ERRATUM TO JOINT PUBLIC NOTICE

February 1, 2016

Project Manager
Sara Fortuna
Permit Application Number
MVN-2015-01259-WKK

DRAINAGE IMPROVEMENTS IN ST. MARTIN PARISH

SECTION "A-A"

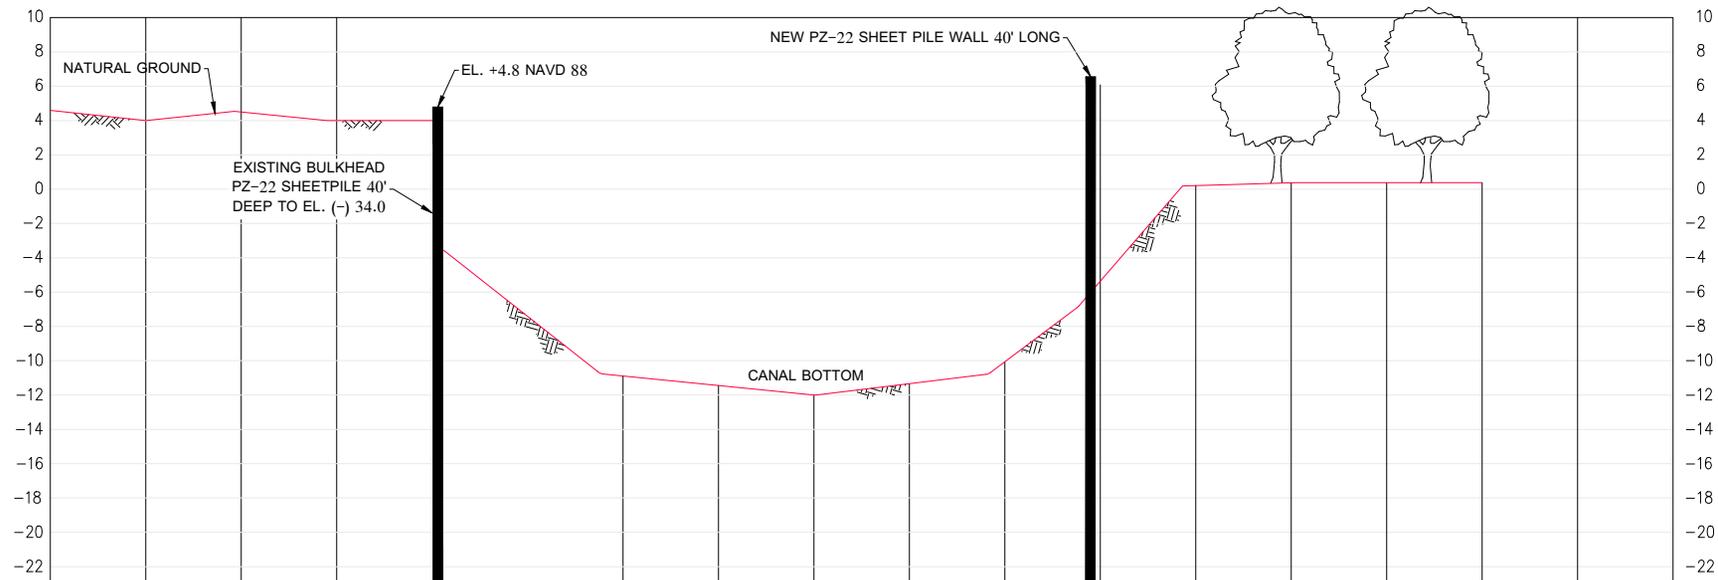
** The purpose of this erratum is to advise of corrections made in the October 26, 2015 public notice, to include the length of sheetpile and the addition of Cross-Section A-A' drawing, which shows the details of the flood gate. Also, adjacent landowners living within the Bayou Estates Subdivision will be notified and able to comment on the project. Therefore, the expiration for receipt of comments has been extended an additional 20 days, until **February 21, 2016**.*
